# Wheels to Wings Cycleway

## Independent design option review – Final

Prepared for	Christchurch City Council
Job Number	CCC-J136
Revision	B
Issue Date	25 March 2022
Prepared by	 Transport Engineering  Road Safety

Figure 2 Cross section in the central section (Submitters design)

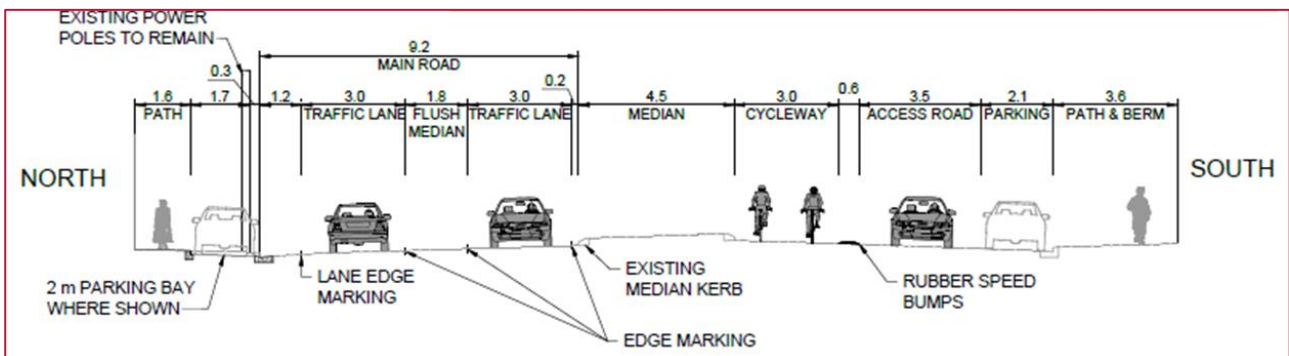
The Submitter's design includes two narrow 3m wide traffic lanes, a narrow 1.8m wide flush median to separate opposing directions of traffic, a 1.2m wide buffer to the kerb on the north side of the carriageway and a 0.2m wide buffer from the central median. On-street parking is provided in indented bays. This design results in the existing power poles being located very close to the live traffic lane, despite a 1.2m buffer shown in the Submitters design. The current situation has the parking lane (approximately 2m wide) providing a buffer to the power poles and the CCC design will move the traffic lane even further away from the power poles.

The layout means that any bus stops (2.7m wide) need to straddle the indented bays and the buffer. The 1.6m footpath adjacent to the bus stop is not sufficient to accommodate people waiting with prams or wheelchairs. Overall, we consider that the walking experience will be less pleasant on north side but obviously improved on the south side with far less traffic adjacent to the footpath.

We are also concerned that the 1.2m buffer could be used/mistaken as an eastbound cycle lane and this unsafe due to the parked cars (risk of dooring). The CCC design provides a better buffer between the footpaths and the traffic lane with the presence of the cycleway and parking spaces.

We also note that any vehicle waiting in the flush median to turn right will effectively block the westbound traffic lane due to the below standard width of both features. Whilst a car could 'sneak' past a vehicle using the flush median, it would need to do so at very slow speed. We do not consider this is an acceptable arrangement for an arterial road.

The proposed cross section on the north side is not considered appropriate for an arterial road (or even a collector road) and we believe it would be flagged in a Road Safety Audit as a 'significant' safety issue.

Figure 2 Right turns into the access lane (Submitters design)

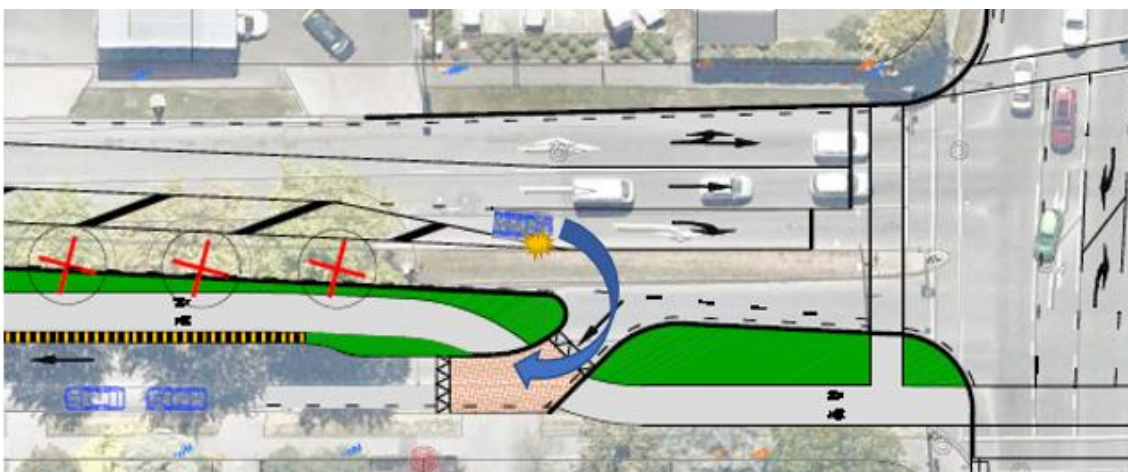
- Proximity of the access road entry locations to major signalised intersections. Poor safety outcomes are expected from right turn movements into the access road, misinterpretation of the intentions of vehicles indicating to turn right (resulting in the risk of rear end crashes), as shown in Figure 2. There is also the potential for queuing back into the main traffic lane as larger vehicles (such as waste collection and delivery vehicles) wait for cyclists using the two-way cycle path.

**We consider that moving all through traffic to the north side of the central median, as proposed in the Submitter's design, is fundamentally unsafe for all road users and will make living on the north side less pleasant.**
